**STATE OF MARYLAND
CRITICAL AREA COMMISSION
CHESAPEAKE AND ATLANTIC COASTAL BAYS**

Re: 2009-0153-V – Prager, Mindy L.

CASE NUMBER 2009-0153-V

VARIANCE PLAN

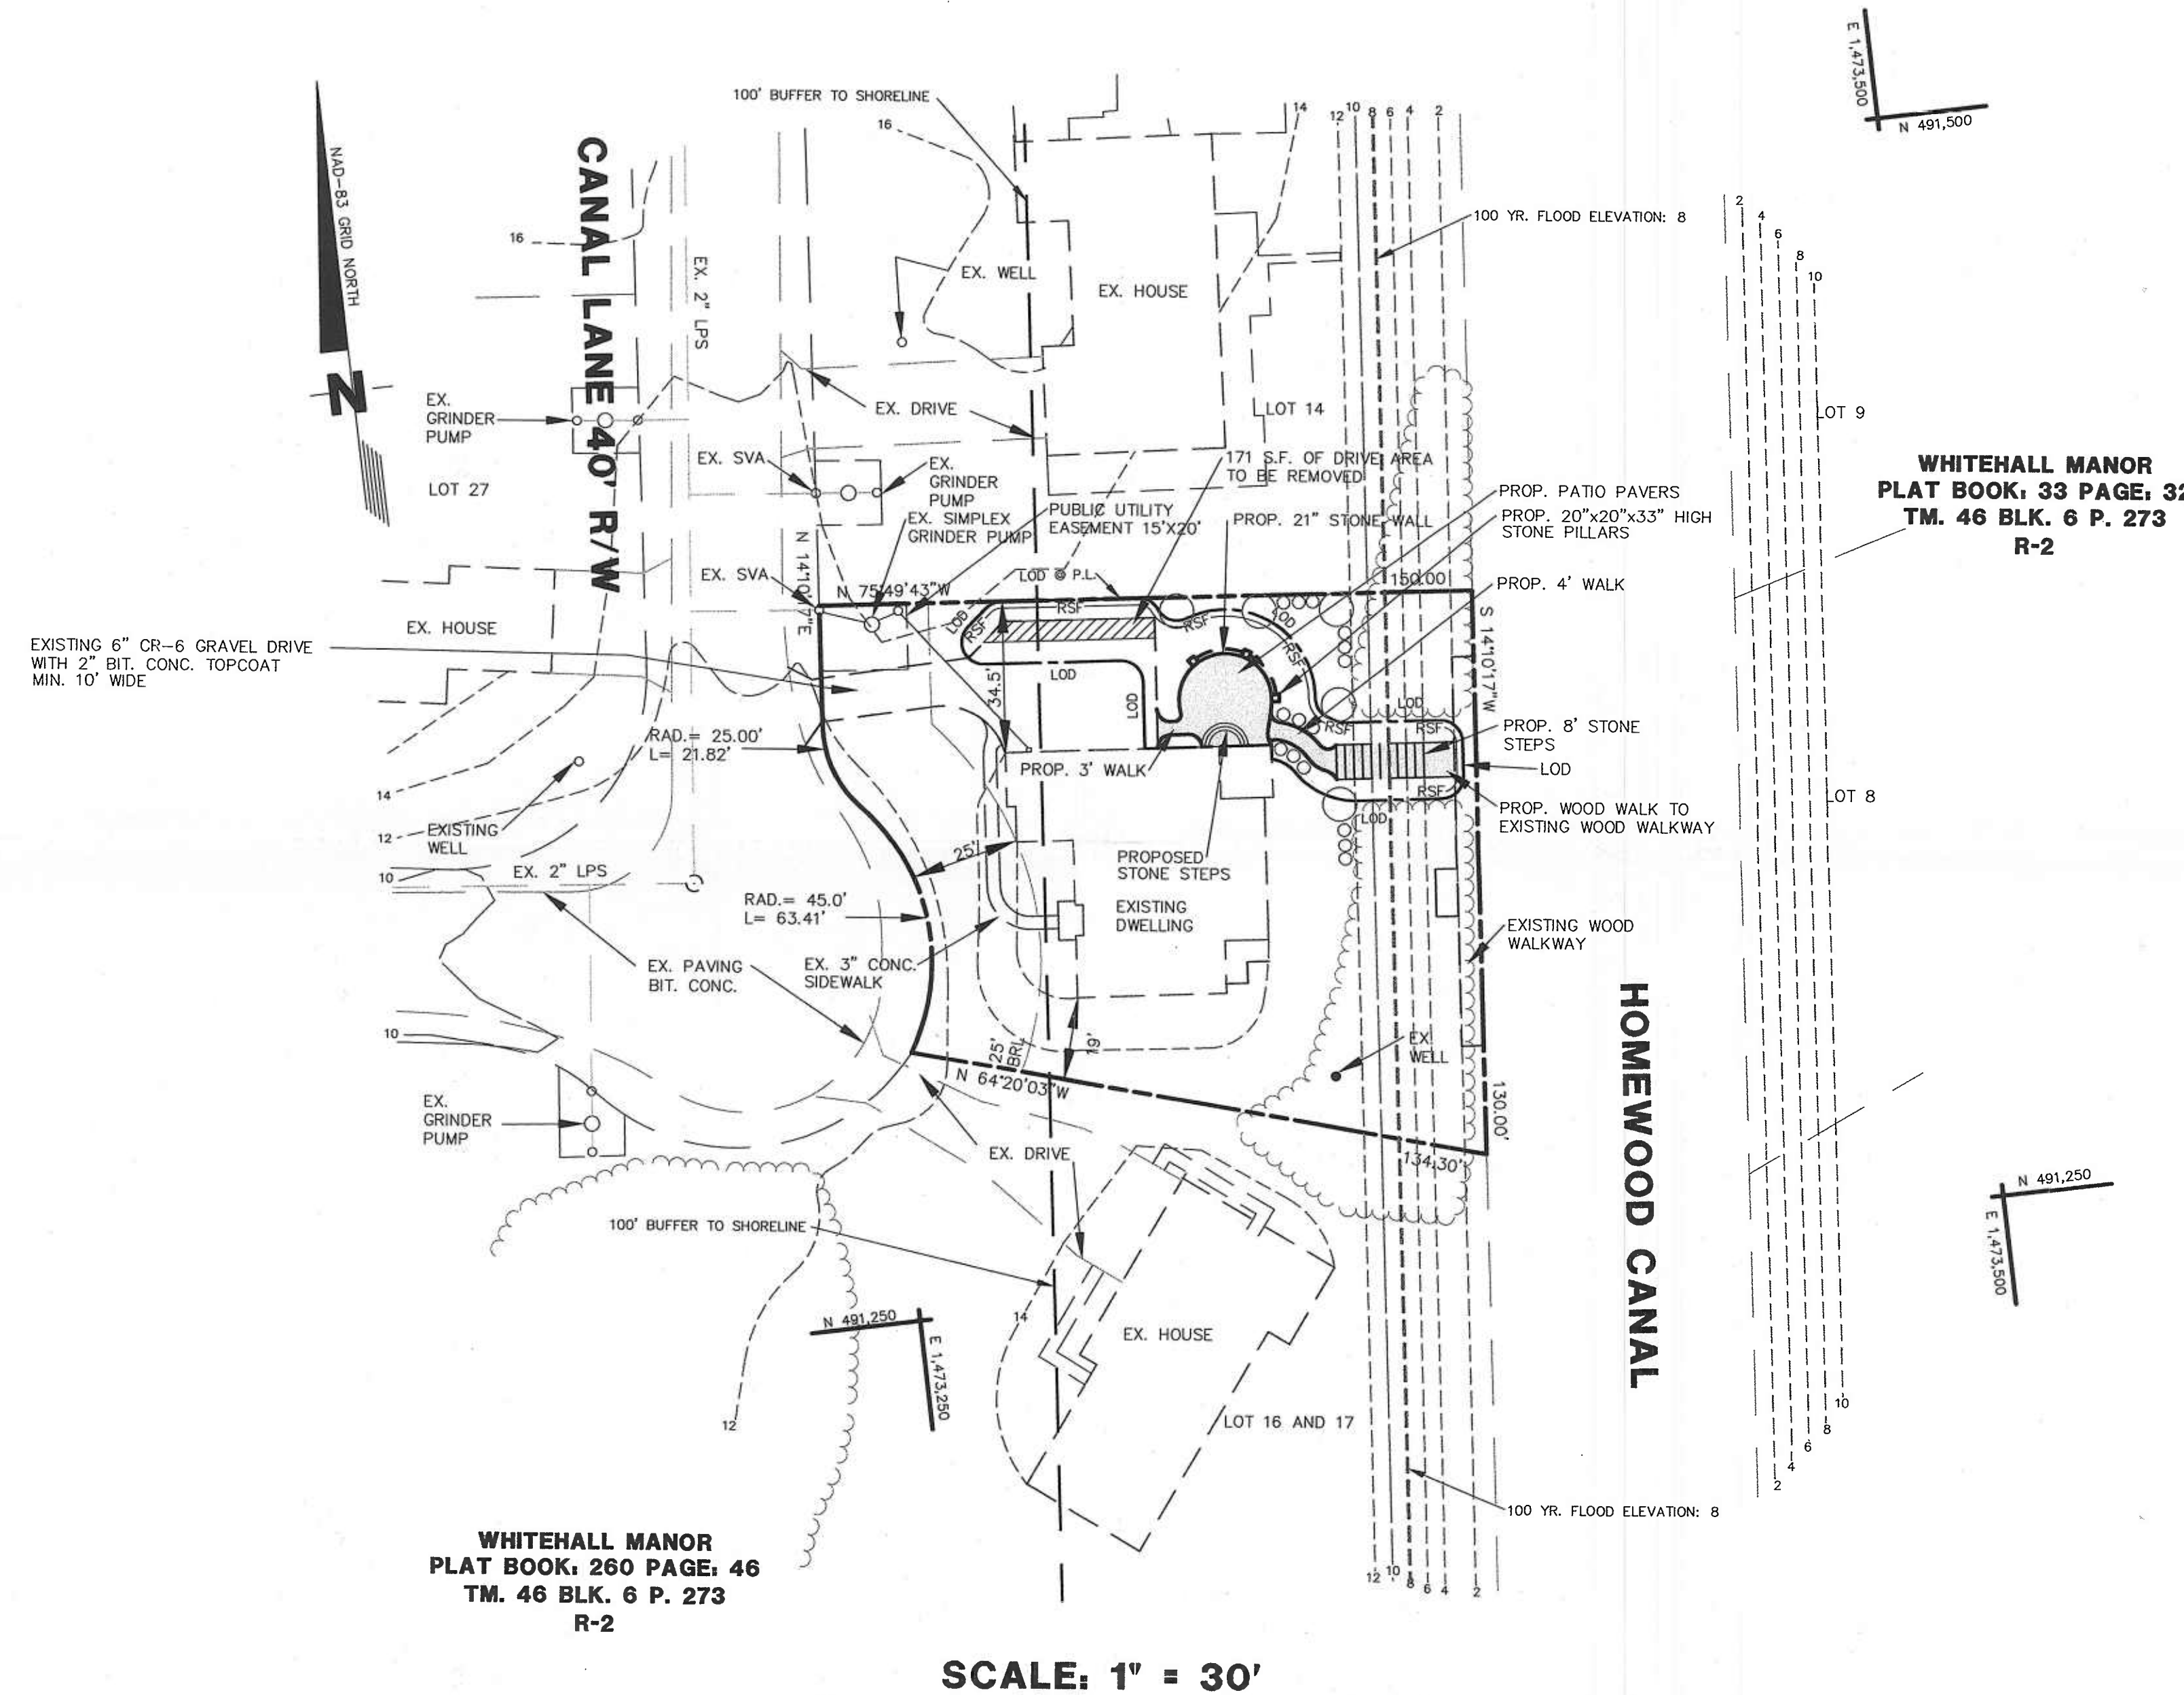
The decision in Case No. 2007-0265-V remains in full force and effect, including the conditions set forth therein. The stone steps may be replaced, as set forth in the 2007 decision, in the location shown on County Exhibit 2 admitted at the hearing on this application. The applicant is required to obtain the necessary permits to remove and replace the stone steps.
